April 8, 1976
GQL 0506

THREE MILE ISLAND NUCLEAR STATION UNIT 1 (TMI-1)
OPERATING LICENSE NO. DPR-50
DOCKET NO. 50-289

RESPONSES TO NRC QUESTIONS CYCLE 2 RELOAD REPORT

FIGURE 3

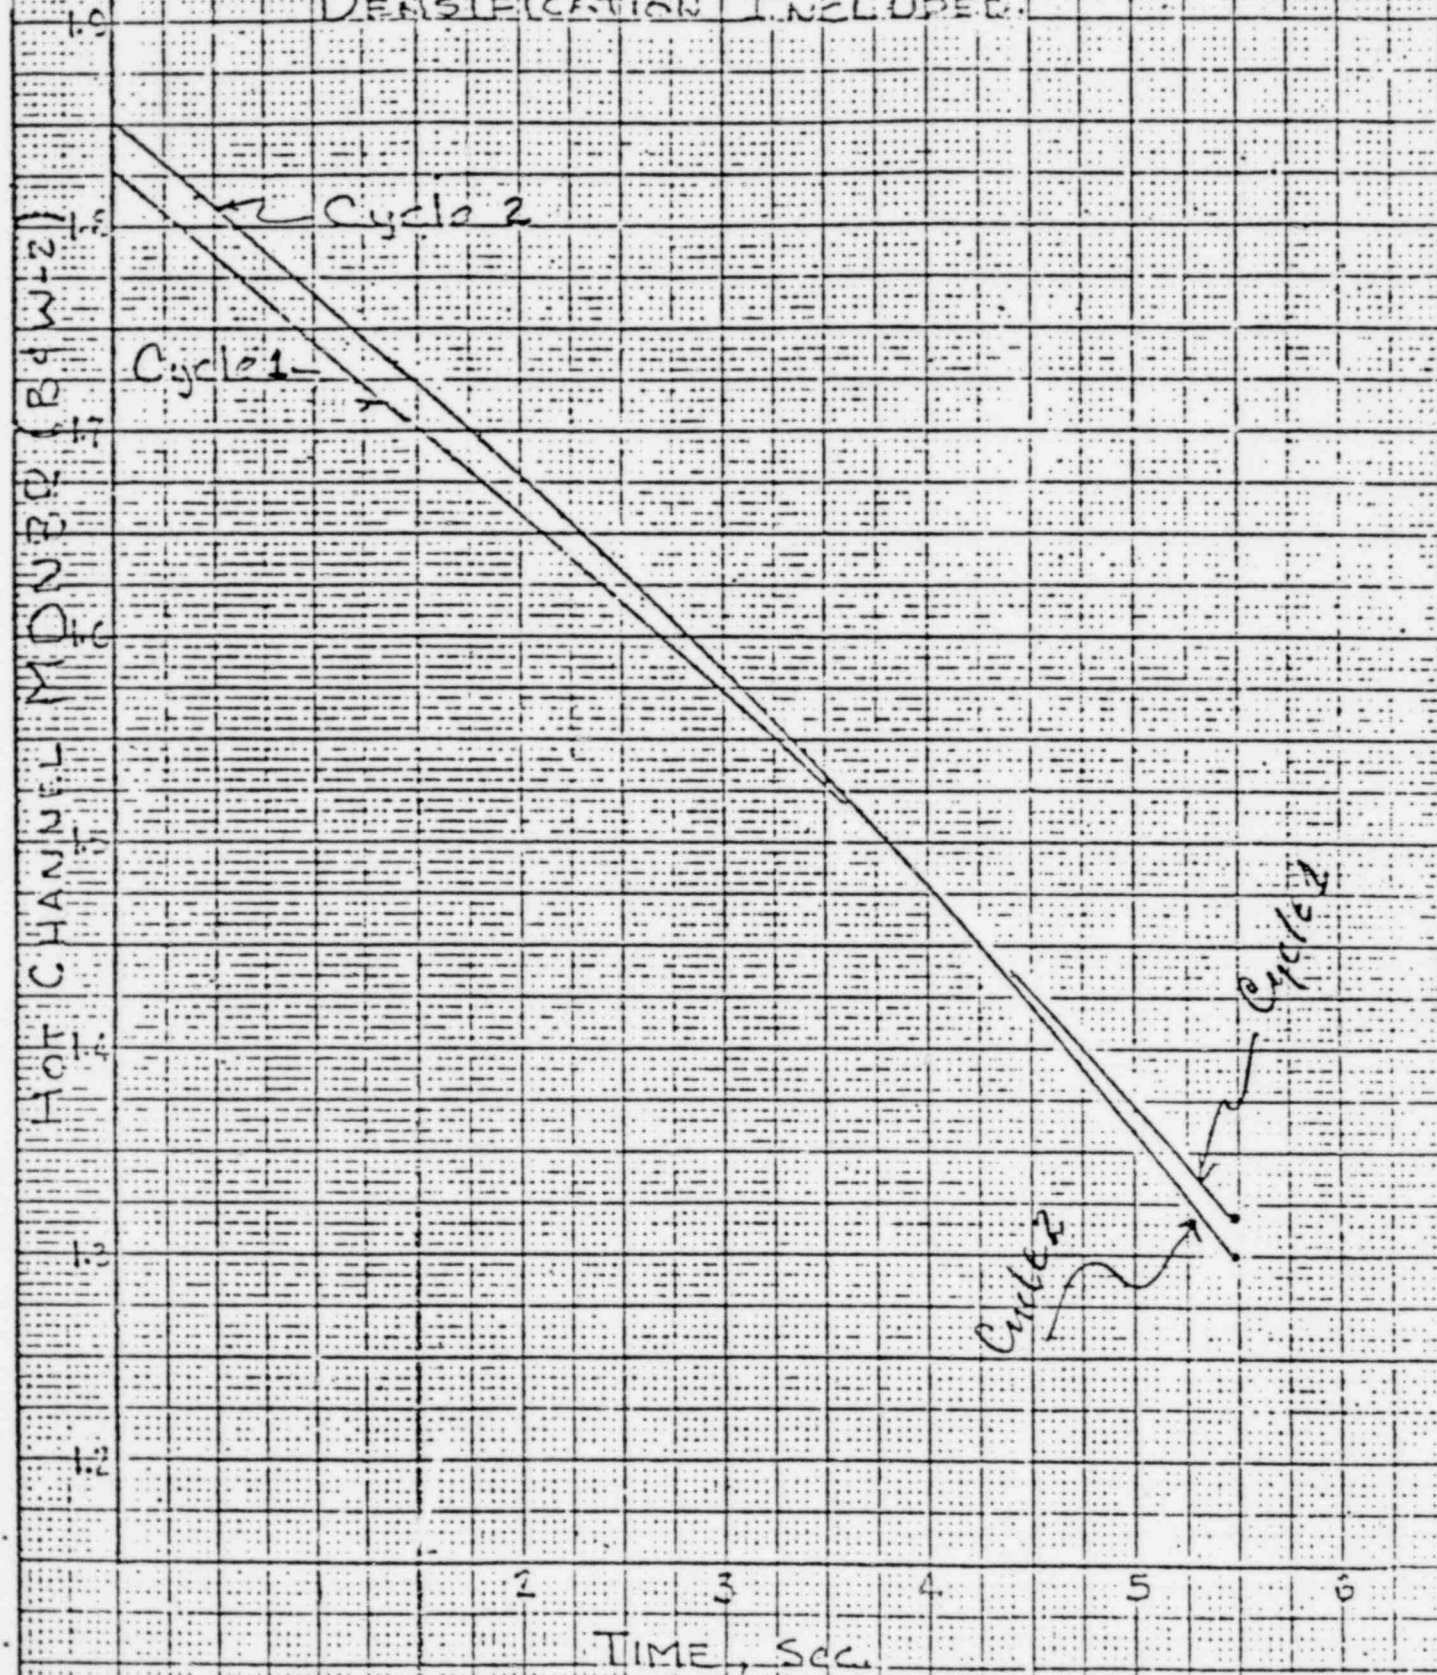
Figure 2 shows the calculated DNBR versus time with the effects of densification included. From this figure it is seen that a DNBR of 1.3 (W-3) is reached at about 3.35 seconds. Using figure 1 and the technique explained previously, this yields a flux/flow ratio of 1.08. This is the value presented in the FSAR Technical Specifications for densified fuel. Figure 3 shows DNBR versus time for a TMI-1 one pump coastdown using the BAW-2 (2) correlation.

Curves are shown for both the cycle 2 analysis and the most recent cycle 1 analysis. Differences in the initial minimum DNBR occur because of the increased flow rate accounted for in cycle 2 (106.5% of design flow) and because of core configuration and fuel assembly modeling differences discussed in the above paragraphs and in section 6.1 of the Reload Report. From figure 3, the limiting design DNBR (1.32 for cycle 1, 1.30 for cycle 2) is reached at 5.45 seconds for both cases. Using the Method defined in III. above, with a trip delay of 1.3 seconds, the maximum allowable flux/flow ratio is then 1.12.
